- Request - Planned Unit Development for Multiple Commercial Buildings on a lot
- Location - 3027 Alexis Road
- Applicant/Owner - Board of Trustees of the Toledo Lucas County Public Library
325 Michigan Street
Toledo, OH 43604
- Architect - Bostwick Design Partnership
2729 Prospect Avenue
Cleveland, OH 44115
- Engineer - DGL Consulting Engineers
3455 Briarfield Blvd, Suite E
Maumee, OH 43537

The staff recommends that the Toledo City Plan Commission recommend **approval** of PUD24-0001, a request for Planned Unit Development for multiple commercial buildings on a lot at 3027 Alexis Road to Toledo City Council for the following **two reasons**:

PLANNED UNIT DEVELOPMENT
TOLEDO CITY PLAN COMMISSION
REF: PUD24-0001
DATE: February 13, 2025
TIME: 2:00 P.M.

SITE PLAN

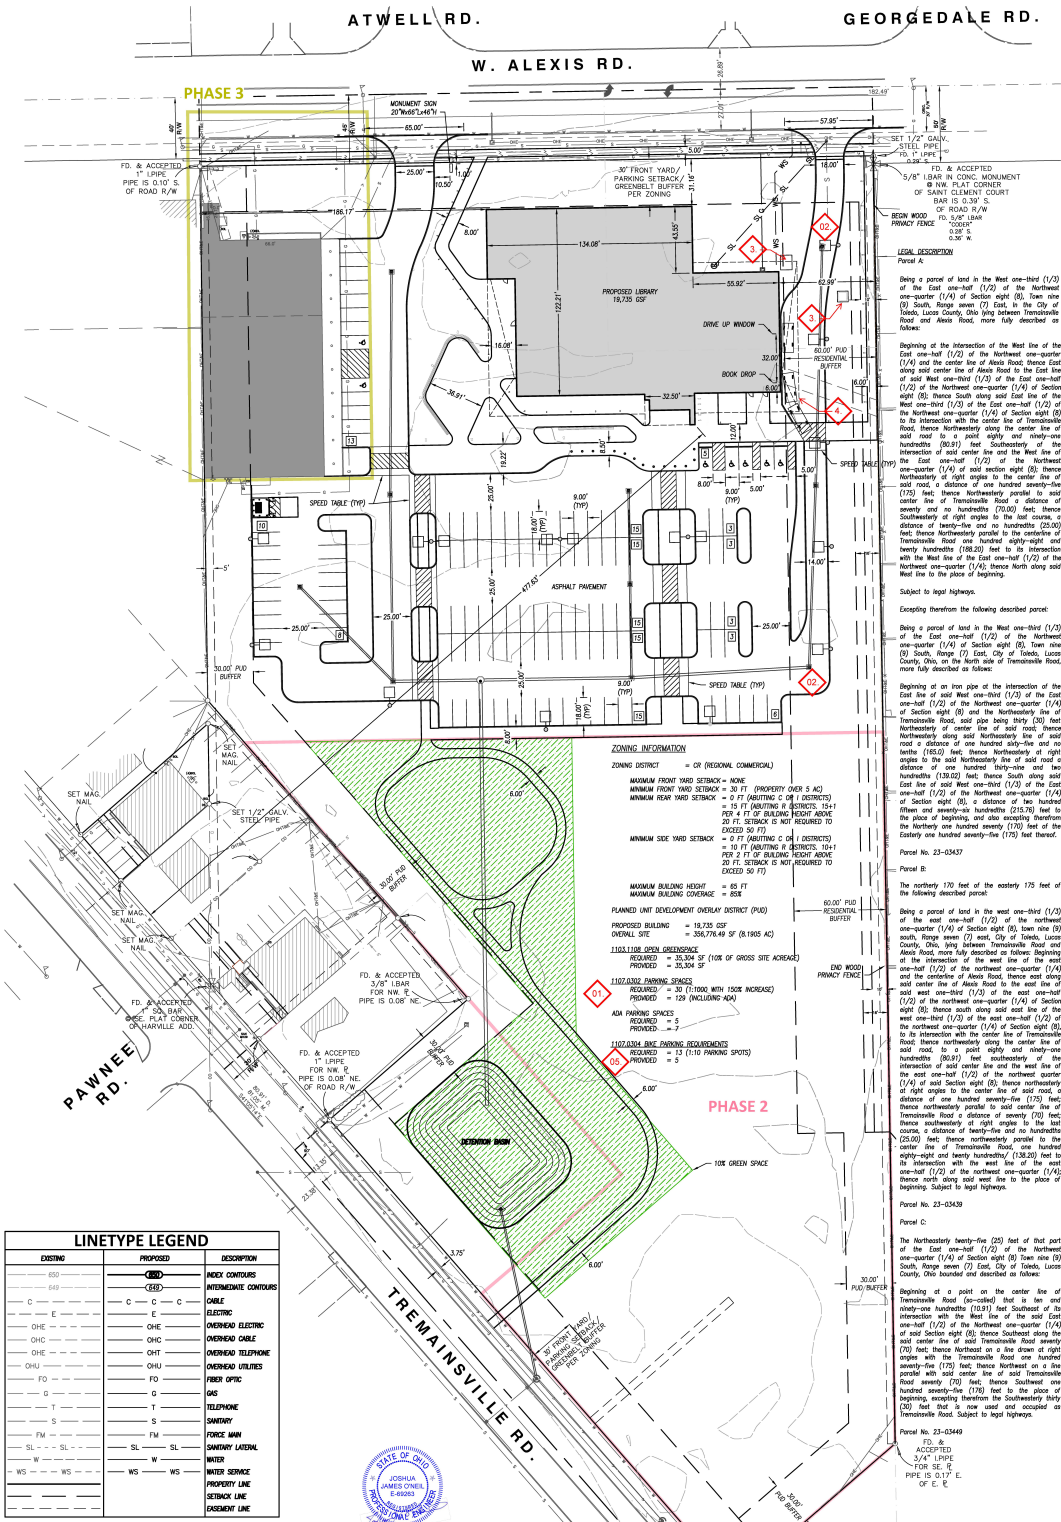
33. Per TMC§1107.0304, the Off-Street Parking Schedule requires one bicycle parking slot per 10 parking spots, requiring a total of thirteen (13). Five (5) bicycle slots are depicted on the site plan. **Not acceptable as depicted. Eight (8) additional bicycle slots shall be provided.**

35. Per TMC§1103.1008(B) commercial PUD developments shall maintain a minimum open space depth of 30 feet on all perimeter property lines and a minimum open space depth of 60 feet when abutting a Residential District. This open space area must be void of buildings, structures, parking areas and other above ground improvements. The submitted site plans and elevations show that a portion of the main building roof, the drive-up material return and service window roof, the drive through lane, a sidewalk, a transformer and a condenser will be located within the required sixty foot (60') open space along the east side of the site. **Not acceptable as depicted. The applicant shall obtain a waiver for the required open space depth where it does not comply.**

38. Traditional detention/retention ponds are prohibited in the front yard per TMC§1108.0206(D). Stormwater treatment facilities shall also meet the approval of the City of Toledo's Division of Engineering Services. **Not acceptable as depicted. The proposed detention basin will need to be relocated so that it is not in the front yard and approved by the Division of Engineering Services.**

- f. Per TMC§1103.1007(H), all telephone, electrical, cable, and other utility appurtenances shall be buried and dumpsters shall be sufficiently screened. **Not acceptable as depicted. Dumpster enclosure details shall be provided.**

LANDSCAPE PLAN - TREES

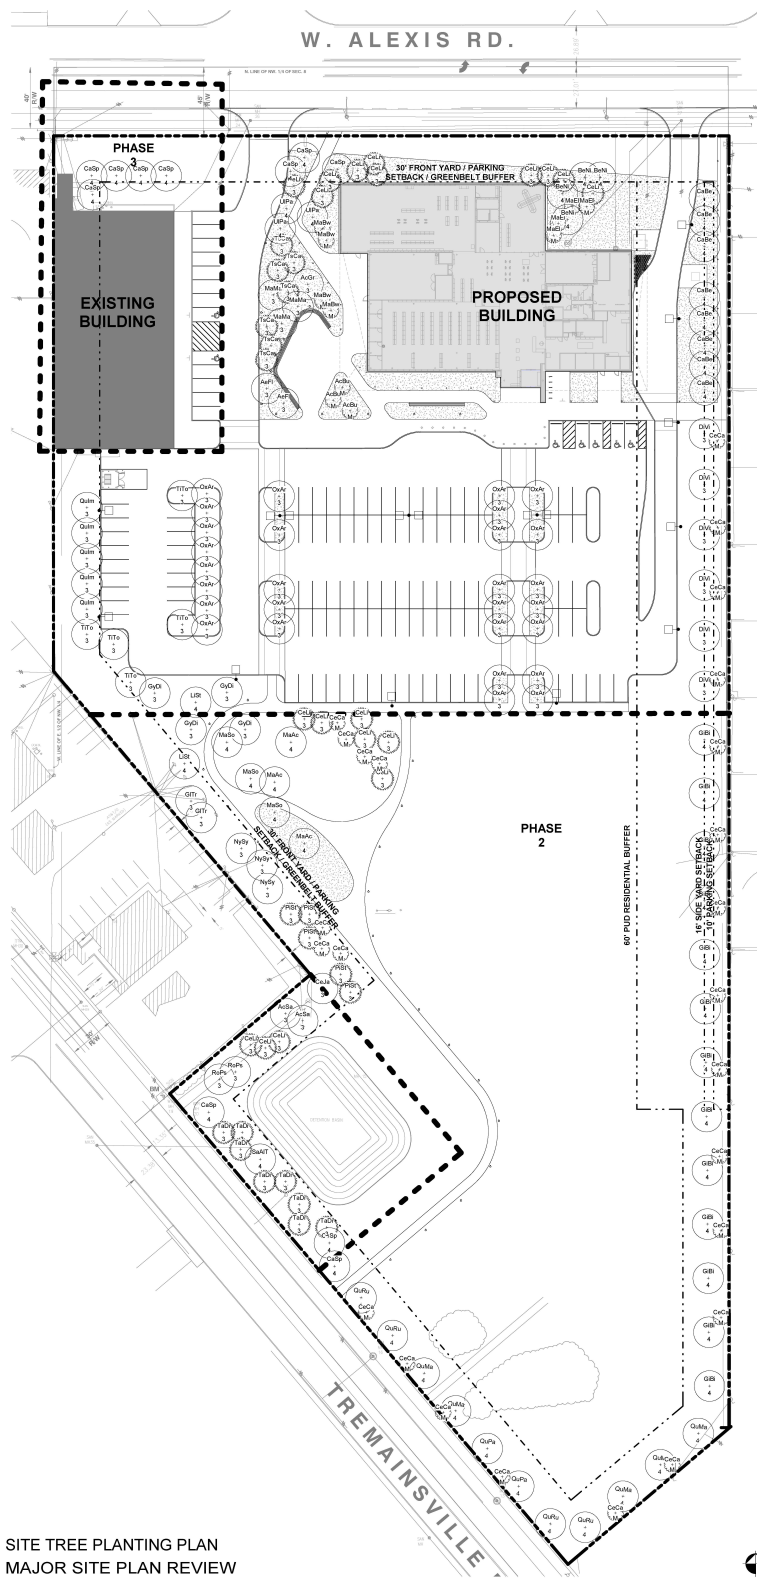
- a. Per TMC§1108.0202, a minimum 30-foot-wide frontage greenbelt along public right-of-ways is required that contains at least one (1) tree for every thirty feet (30') of frontage. This applies to the north and south sides of the property. **Acceptable as depicted. While acceptable as depicted, any evergreen trees installed in the frontage greenbelt must be a minimum of eighteen feet (18') from the curb or pavement edge per TMC§1107.2000.**

- b. Per TMC§1108.0203, a Type A buffer is required along a portion of the east property line and a Type B Buffer is required along the other portion of the east property line. These two (2) buffers require a total thirty-four (34) canopy trees and 127 shrubs along the eastern property line. The landscape plan depicts twenty-seven (27) canopy trees and twelve (12) understory trees for an equivalent of thirty-five (35) canopy trees. The site plan also depicts 136 shrubs. **Acceptable as depicted.**

LANDSCAPE PLAN - SHRUBS

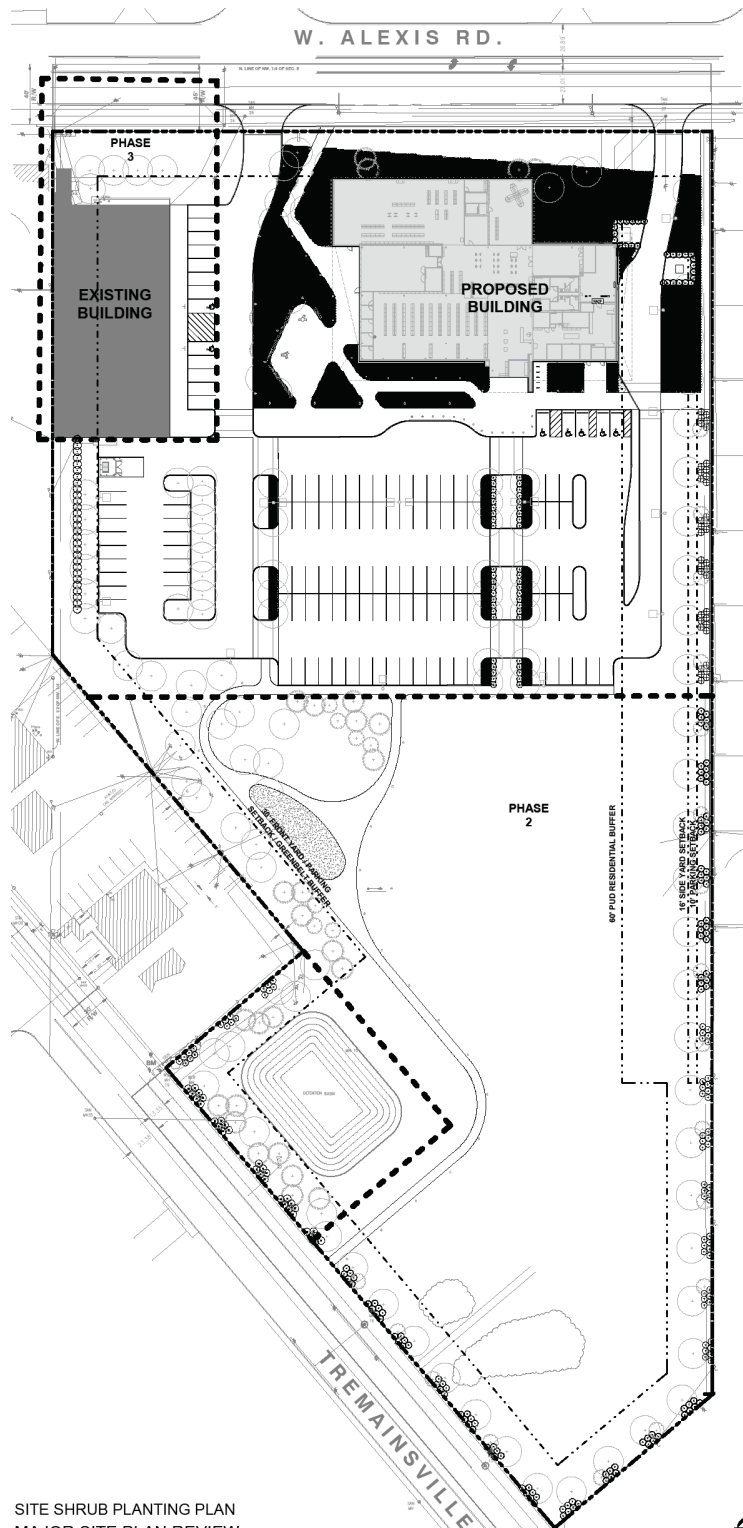
- c. Per TMC§1108.0204, two (2) canopy trees and six (6) shrubs are required to be installed in interior landscape areas in a parking lot for each ten (10) parking spaces. A total of twenty-six (26) trees and seventy-eight (78) shrubs are required in the interior of the parking lot based on the proposed 129 parking spaces. The submitted tree planting plan and shrub planting plan depict thirty (30) trees and forty-six (46) shrubs. **Not acceptable as depicted. An additional thirty two (32) shrubs are required.**

- d. Perimeter landscaping must be installed along any parking lot area adjacent to a street, place or driveway, or which is visible from an adjacent property. The tree planting plan and shrub planting plan depict trees and shrubs along the west side of the parking lot, and trees and a six-foot (6') high cedar privacy fence along the east side of the parking lot. **Not acceptable as submitted. The proposed continuous shrub hedge depicted on the shrub planting plan along the west side of the parking lot shall be extended to the south to include the drive aisle. The shrub hedge shall consist of evergreen shrubs. The privacy fence is acceptable in lieu of the required continuous shrub hedge along the east side of the parking lot per the Plan Director.**

- e. Per TMC§1108.0205(B), one 2-inch caliper tree for every 1,000 square feet of building coverage, foundation plantings along all portions of the building that are visible from the public rights-of-way, and landscaping at all major building entrances are required. **Not acceptable as depicted. A mix of trees, shrubs and groundcover shall be provided as foundation plantings along the entirety of the north, west and east sides of the building as well as at the main entrance.**

ELEVATIONS

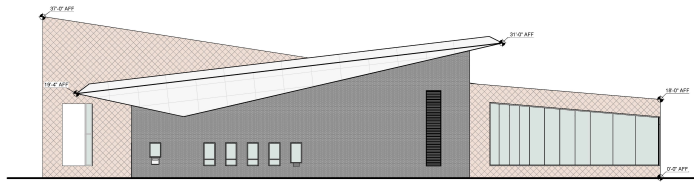
- n. The location, lighting, and size of any signs.
40. Landscaping shall be installed and maintained indefinitely.
41. Building elevations must meet TMC§1109 – Design Standards. The submitted elevations show a mix of proposed building materials including brick, stainless steel wall tiles, ultra-high performance concrete panels, and aluminum composite panels. Final building materials and colors have not been decided. **Not acceptable as submitted. Final elevations that include building materials and colors will need to be submitted that meet the standards of TMC§1109.**
